14 July 2025

OBJECTION SUBMISSION TO STATE SIGNIFICANT DEVELOPMENT APPLICATION NO. SSD-76555711 FOR DEMOLITION OF EXISTING STRUCTURES, CONSTRUCTION OF A 35 STOREY MIXED USE DEVELOPMENT WITH IN-FILL AFFORDABLE HOUSING, ASSOCIATED LANDSCAPING, AND PUBLIC DOMAIN WORKS 3-5 HELP STREET, CHATSWOOD (SP 134 AND SP 52320)

Figure 3: Proposed building separation from 1 Cambridge Lane
Source: Milestone, 2023

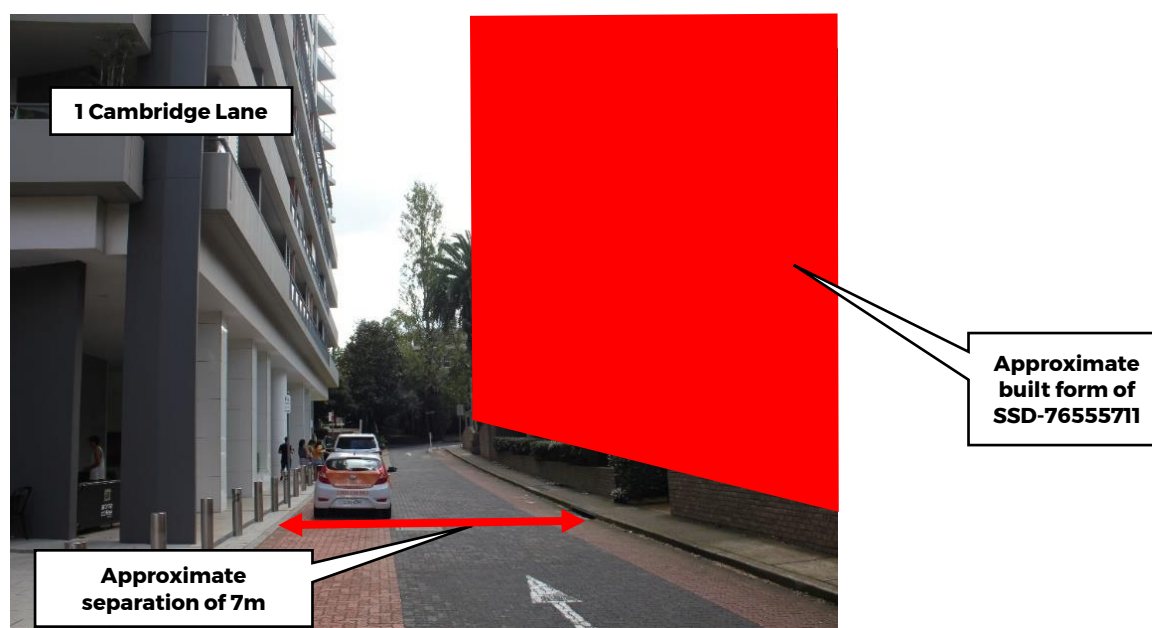
The separation between our client's eastern building elevation and the subject site is the width of Cambridge Lane plus 1m, which is approximately a separation of 7m, as shown in **Figure 3**. The proposed building separation between No. 1 Cambridge Lane and the proposed tower building is 16.79m as shown on the Proposed Site Plan, Drawing No. SSDA-0110 prepared by EM BE CE.

The proposed built form results in an unacceptable non-compliance with Part 2F of the *Apartment Design Guide* (ADG), and this non-compliance will result in a significant unarticulated interface conflict between the apartments at No. 1 Cambridge Lane and the proposed development.

Milestone notes that the ADG Assessment fails to address Part 2F of the ADG, which also establishes baseline building separation distances to ensure that new development is appropriately scaled and delivers acceptable residential amenity outcomes, including visual and acoustic privacy, natural ventilation, access to sunlight and daylight, and outlook.

Figure 4: Southern Elevation of SSD-76555711; Approximate ADG building separation control
Source: EM BE CE (Architectural Design Report, dated 7 May 2025)

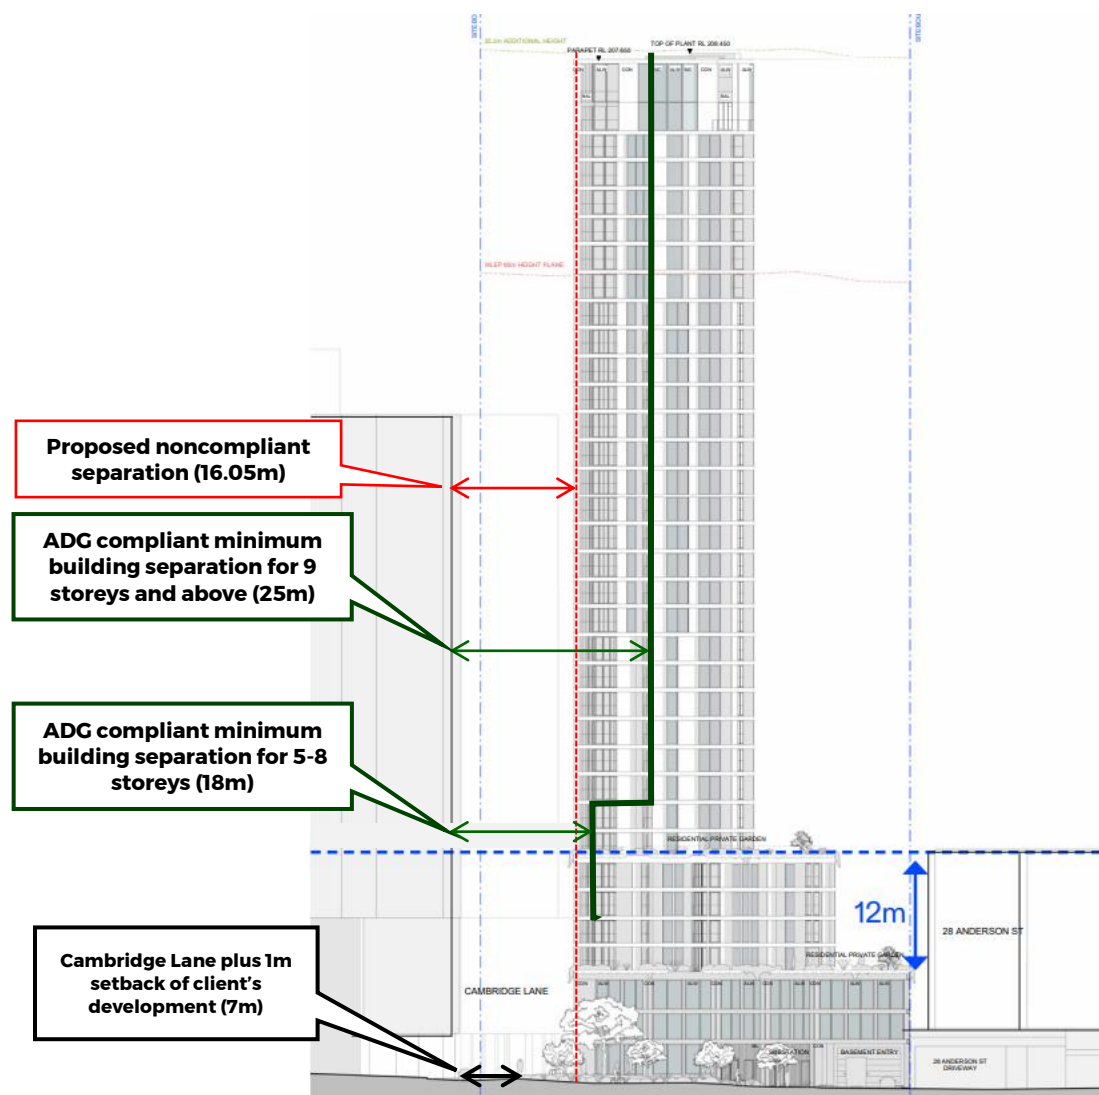
The proposed tower development presents a significant interface conflict, with serious privacy impacts and a substantial loss of residential amenity for the affected apartments at No. 1 Cambridge Lane. An indicative building outline is provided in **Figure 4** and illustrates the extent of the required ADG-compliant separation compared to the western façade of the proposed development. The non-compliance from Level 5 and above directly results in unacceptable amenity impacts for existing residents.

This planning outcome is unreasonable and entirely unacceptable. A new tower development must be required to fully comply with the minimum separation distances prescribed by the ADG. While EM BE CE justifies the non-compliance by noting the minimisation of habitable rooms on the western elevation and the inclusion of privacy and solar screening, this is not supported by the plans. Habitable room windows are still present on this elevation from Levels 5 to 31, and operable privacy screens are only applied to bedroom windows. As such, this response does not represent an adequate or effective mitigation strategy for the reduced building separation, which detrimentally affects all residential levels at No. 1 Cambridge Lane. The most affected apartments are single oriented east-facing apartments at No. 1 Cambridge Lane.

Figure 5: Southern Elevation, SSD-76555711
Source: EM BE CE (Architectural Design Report, dated 7 May 2025)

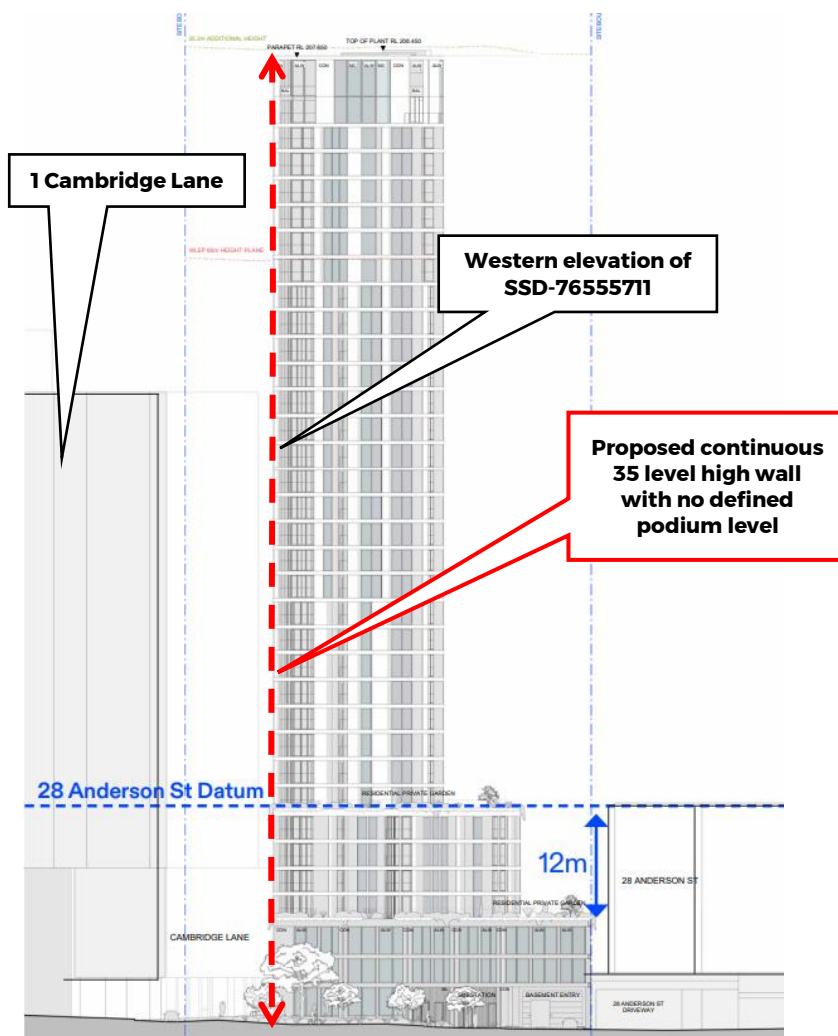
The proposed development consists of a part two part three storey podium level and a 33 storey residential tower which steps up in defined levels from east to west. The current built form of the proposal has no defined podium level for the western elevation which fronts Cambridge Lane. There is a portion of defined podium located in the north of the subject site which extends to a limited part of the subject site's Cambridge Lane frontage. For the majority of the western elevation of the proposed development, the built form presents as a 35 storey continuous high wall with no defined levels to break up the building mass, as shown in **Figure 5**.

The lack of articulation of the western elevation of the proposed development, coupled with the inadequate and non-compliant building separation distances of the ADC (refer to Section 2.1 of this submission), presents a significant visual bulk and interface conflict between our client's site and the subject site.

Figure 6: View Loss resulting from SSDA for Unit 1503 (Level 15), 1 Cambridge Lane, Chatswood
Source: Milestone, 2025

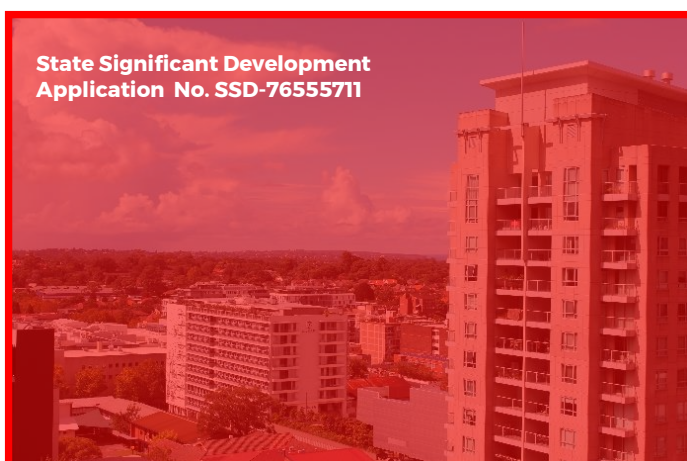
The image in **Figure 6** was taken on the balcony of Unit 1503 which connects directly to the primary living areas of the apartment. The existing image indicates that North Head can be clearly identified to the left of one of the Regency Towers, which is a significant iconic view that will be completely lost as a result of the proposal.

A total of 44 east-facing and south-east facing apartments located at No. 1 Cambridge Lane will be significantly adversely impacted by the proposed development. Based on this, Milestone considers a more comprehensive and balanced evaluation of the potential visual impacts, particularly from the perspective of affected nearby residents, is essential before a responsible planning determination can be made.
